Moredale Childrens Home, 18 Livingston Drive, Liverpool, L17 4LR National Grid Reference: SJ 37211 87273

Mitigation in Relation to Bats and Additional Information in Response to MEAS

Issued: 23rd August 2017

Figure 1: Landscaping plan showing trees to be removed

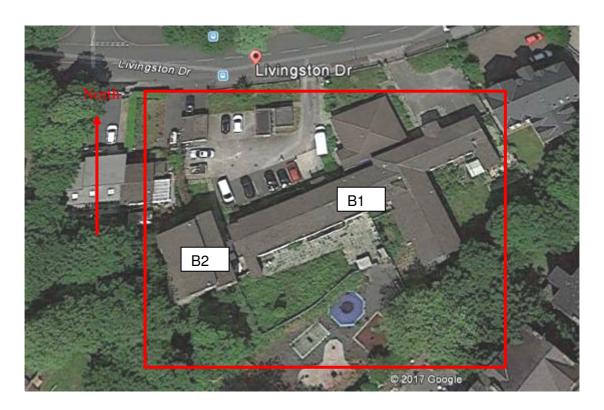
- No significant foraging habitat to the rear of the site to be lost as a result of the proposals; the landscaping plan (Figure 1) indicates the loss of two trees. The new roost will not be at any further distance from those foraging places; mitigation proposals relative to the status of the roost are seen to be the most productive way forward that will retain opportunities for the single crevice dwelling Pipistrelle bat.
